Project	IEEE 802.16 Broadband Wireless Access Working Group < http://ieee802.org/16 >	
Title	Enhancements for AAS support in IEEE 802.16-REVd	
Date Submitted	2003-12-29	
Source(s)	Yigal Leiba Zion Hadad Yossi Segal Itzik Kitroser Runcom Ltd. Hachoma 2 St. 75655 Rishon Lezion, Israel	Voice: +972-3-9528440 Fax: +972-3-9528805 yigall@runcom.co.il yosis@runcom.co.il zionh@runcom.co.il Itzikk@runcom.co.il
Re:	Working Group re-circulation Ballot #13a Announcement	
Abstract	Enhancements for AAS support, to enable operation in degraded S/N environment with improved dynamic response of the antenna array	
Purpose	Adoption of proposed enhancement into P802.16-REVd/D3-2003	
Notice	This document has been prepared to assist IEEE 802.16. It is offered as a basis for discussion and is not binding on the contributing individual(s) or organization(s). The material in this document is subject to change in form and content after further study. The contributor(s) reserve(s) the right to add, amend or withdraw material contained herein.

Enhancement on AAS support in IEEE 802.16-REVd

Figure aaa

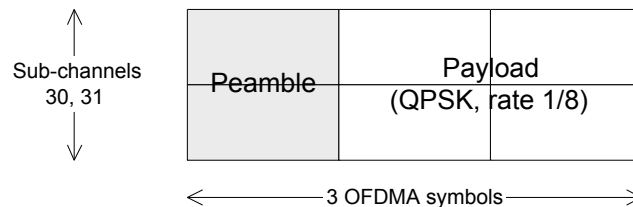
Comment type	Starting page	Starting line	Fig./Table	Section
	Technical, Non-binding	457	32		8.4.4.7
Comment	In high S/N conditions, synchronization based on DL preamble alone may not suffice

“8.4.4.7 Optional active DL AAS scan

Sub-channels 30 and 31 of the DL frame may be dedicated at the discretion of the BS for active AAS scanning. When these sub-channels are used for this purpose, they shall not be allocated in the normal DL_MAP message.

These sub-channels will be used to transmit the AAS_DL_SCAN_IE(), whose physical construction is shown in figure aaa. The AAS_DL_SCAN_IE() is transmitted with a well known modulation and coding, namely QPSK rate $\frac{1}{8}$ with 4 repetitions.
